in the matter of: an application by Ryman Healthcare Limited for resource consent to establish and operate a comprehensive care retirement village at 100-104 Park Terrace and 20 Dorset Street, and 78 Park Terrace, Christchurch

Summary of evidence of Josie Schröder on behalf of Christchurch City Council

29 January 2021

RMA/2017/2588 – s127 elevation (illustrated below)

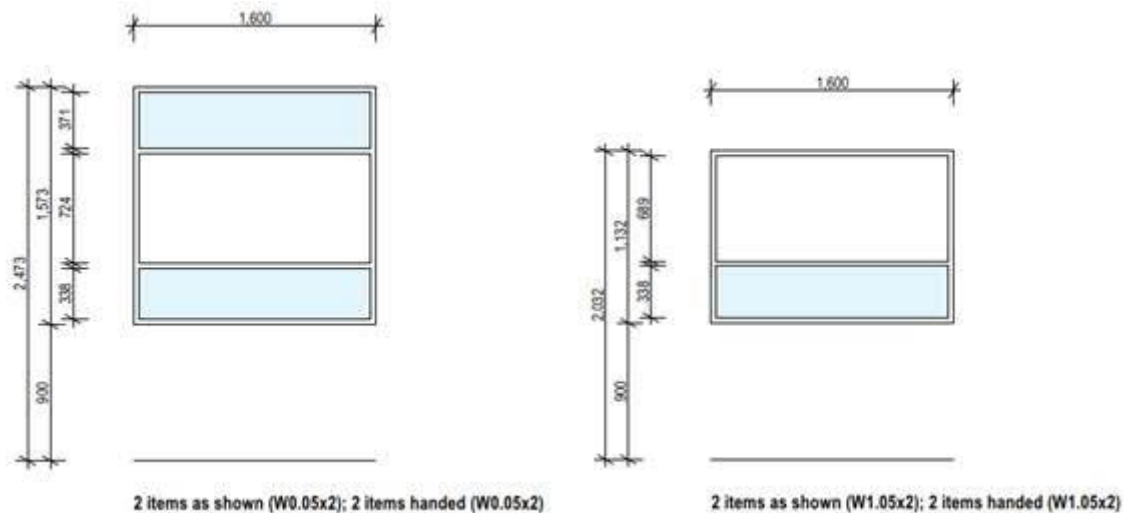
- In paragraph 82 in respect to 4A Dorset Street, the consented Stables building, I discuss the extent of the potential for visual dominance effects on the residential amenity of future occupants. I assessed the proposal in relation to the s127 plans as I considered them the most recent. The opacity of the south facing windows was not noted on the southern elevation of those plans as illustrated below. If however, the windows are to be opaque, I would agree with Mr Burns that there will be no immediate impact from the southern view from the Stables building.

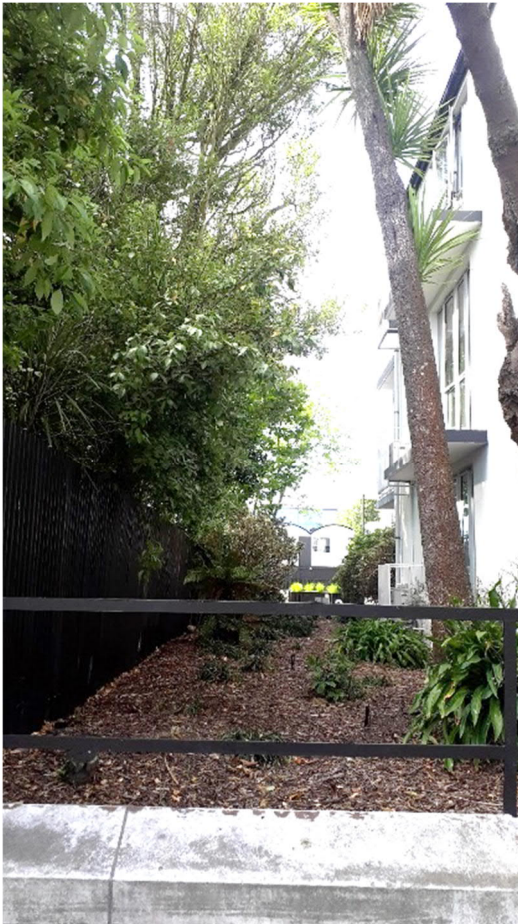
46. In regard to the Salisbury Street interface, I do not consider that Salisbury Street is a more urban environment than Park Terrace, rather I consider that it has a lesser amenity derived from the extensive hardscape of the public space of the street, and the edge conditions including vacant sites. I do not agree with Mr Burns as originally stated in his summary of evidence that the "B07 frontage to Salisbury Street is appropriately differentiated... reflecting the hierarchy of the streets." Rather I consider that more focus has been placed on the interface with Park Terrace through the design process, with less consideration of the amenity and quality of the interface of Salisbury Street, or the nuanced approach utilised elsewhere on the Peterborough Site.

47. The north and south elevations of B02 are still in my view incongruous with more finely detailed aspects of the proposal including the interface directly between B02 and Park

Terrace. While angled away from the street boundary, the north and south elevations are tall, blank and of a potentially highly reflective colour and material. I consider these elevations will be visually incongruous within the street environment and result in a visual dominance effect to users of the street. Ms Skidmore noted in her response the transience of users in respect of this. While I do not consider that people will stand and look at these elevations, in my understanding of this environment as a resident of Ōtautahi/Christchurch and a user of this area there are many local residents and regular users of this area.
